CIVIL ENGINEERING REPORT INCORPORATING WATER CYCLE MANAGEMENT STRATEGY (UPDATED FOR RTS)

**PROSPECT LOGISTIC ESTATE
SSD 10399
CLUNIES ROSS STREET
GREYSTANES NSW**

Rev: C

Revision B of this report has been completed to address agency Response to Submission (RtS) received by the department. In particular the civil engineering items raised by Blacktown City Council in their information request letter dated 18 September 2020 and Cumberland City Council in their information request letter dated 16 September 2020 – refer **Section 10.4**.

DRAWING TITLE
CONCEPT STORMWATER DRAINAGE
PLAN
SHEET 1
DRAWING NO. C013251.06-DA41

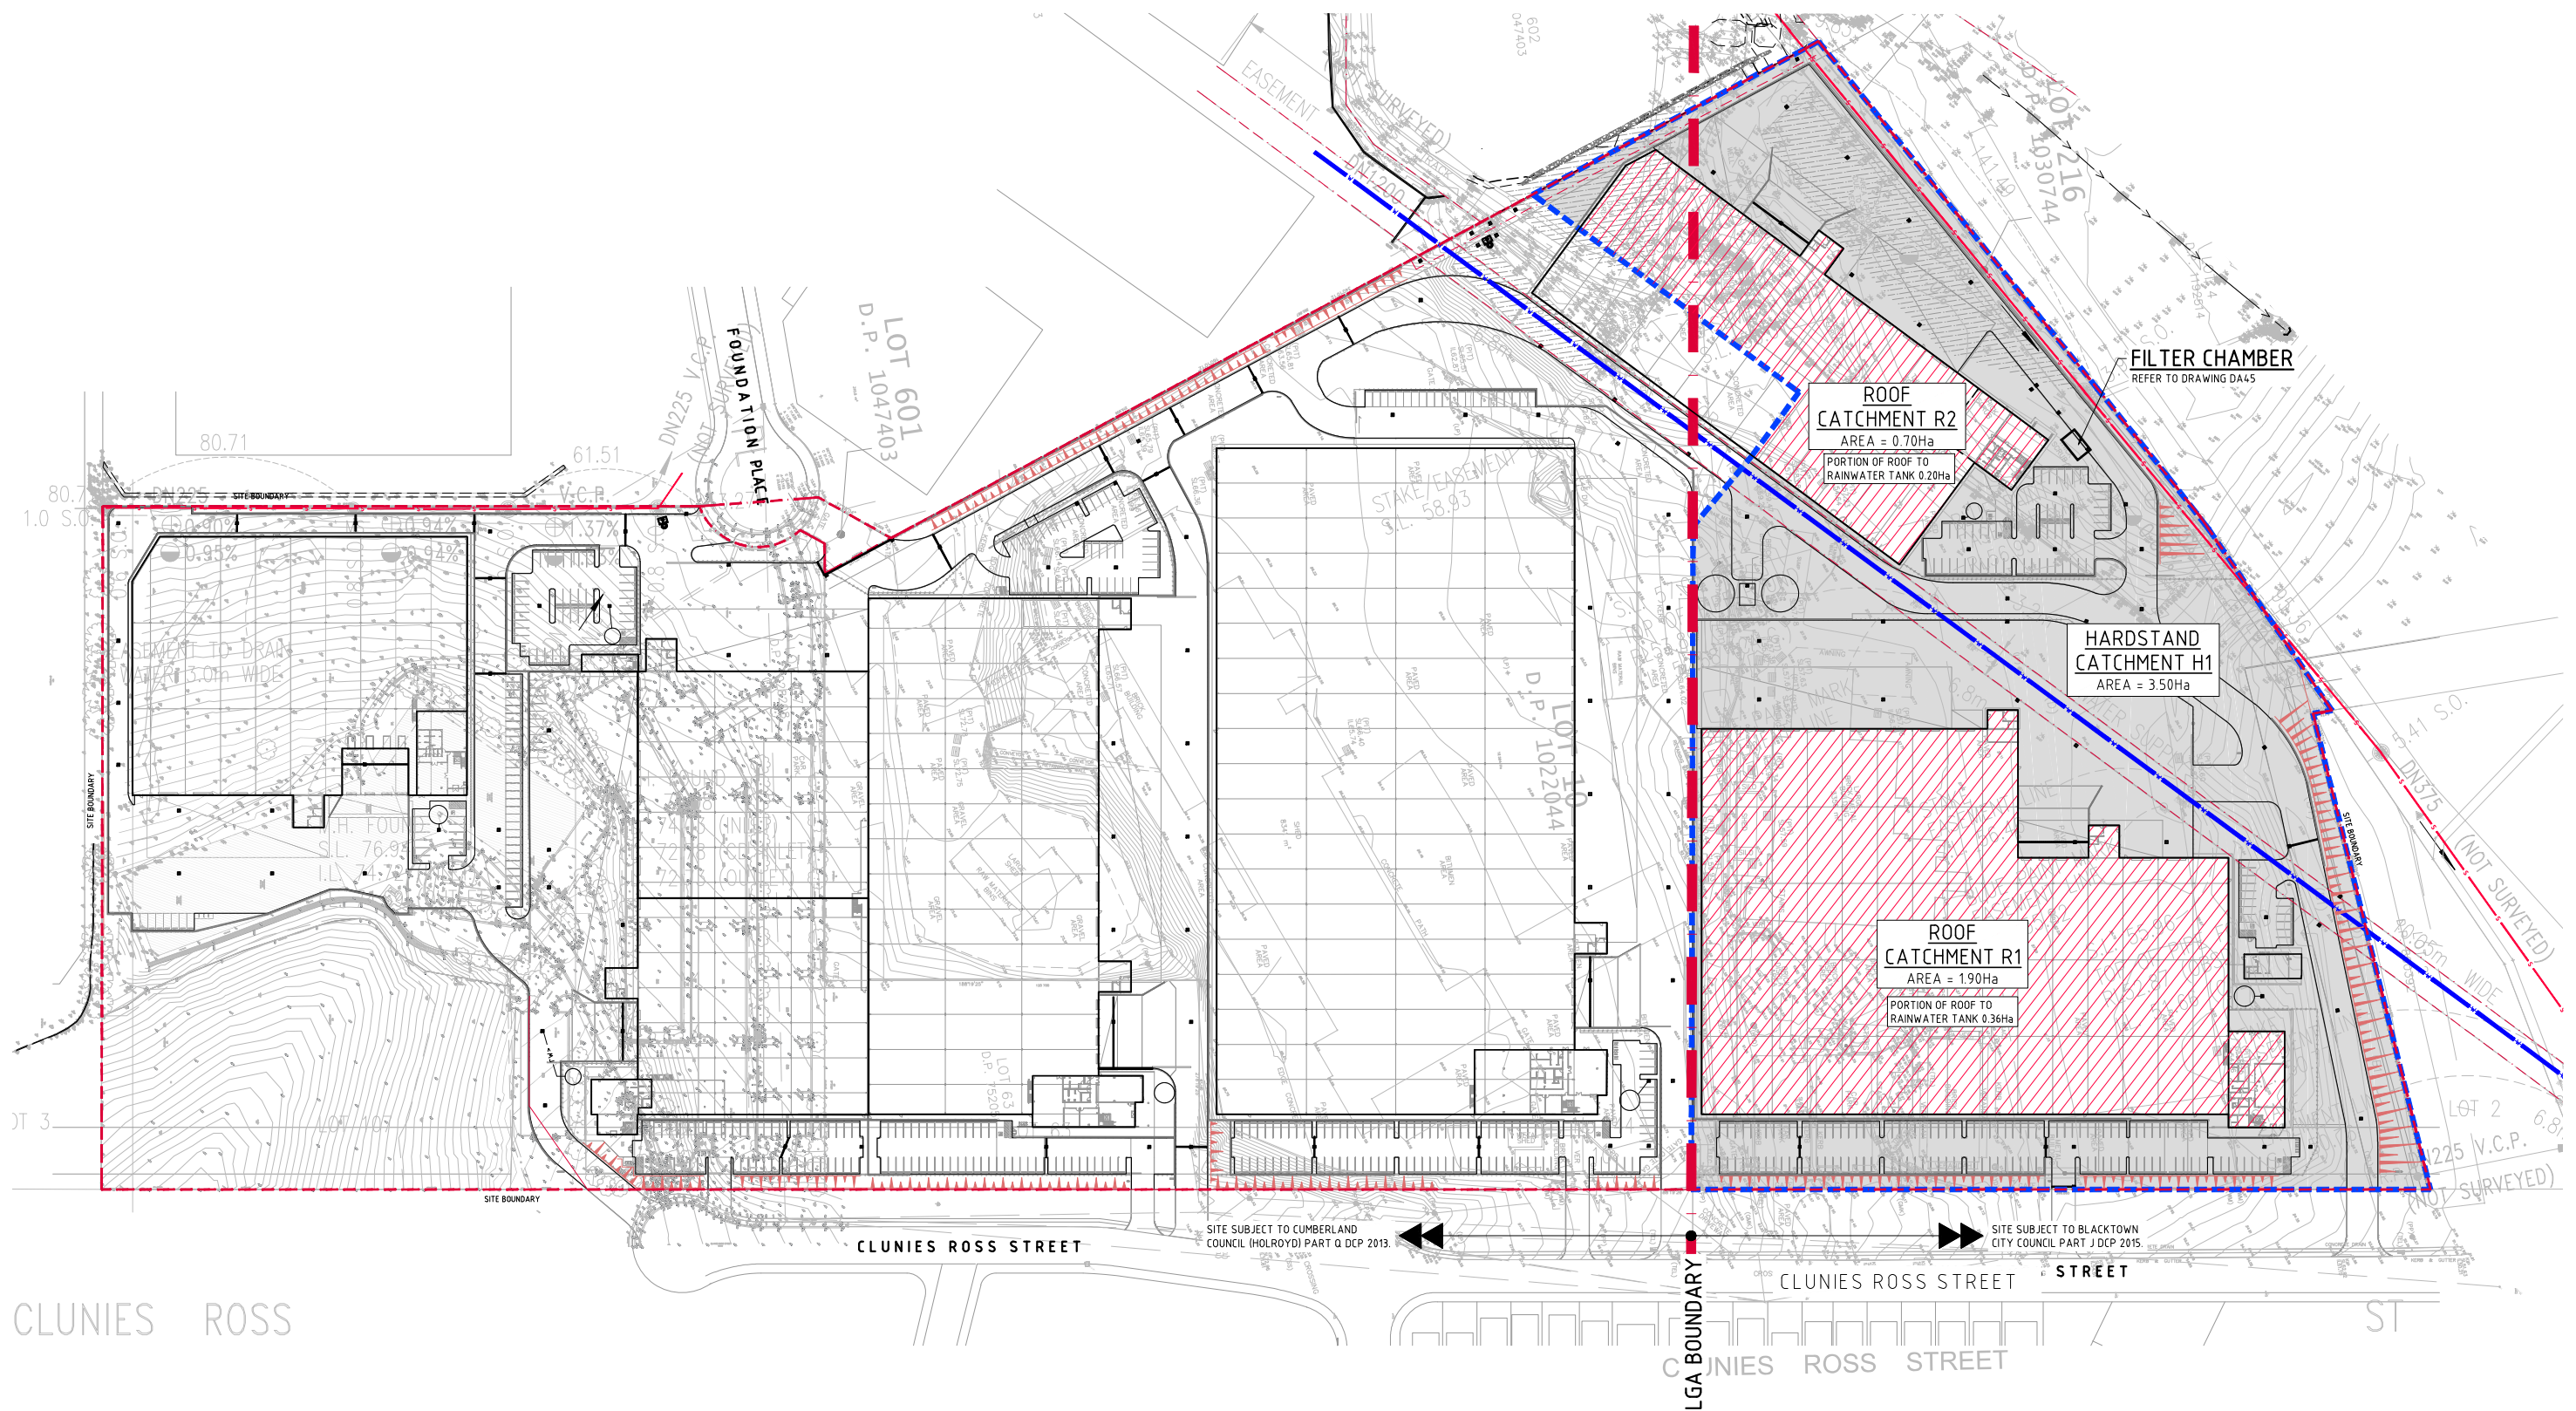
No.	Item and Response
	LGA. Note, we have included a second MUSIC model for areas within CCC LGA pertaining to rainwater tank sizing only.
Item 19)	<i>Provide a MUSIC catchment plan that shows both the land use and the areas contributing to each specific device. To make this more understandable it may be easier in many cases to split these into two separate plans.</i> <u>Response</u> Overall catchments are shown on drawing Co13251.06-DA40. A separate MUSIC catchment drawing (Co13251.06-DA43) has been prepared for the BCC LGA zone.
Drains Modelling
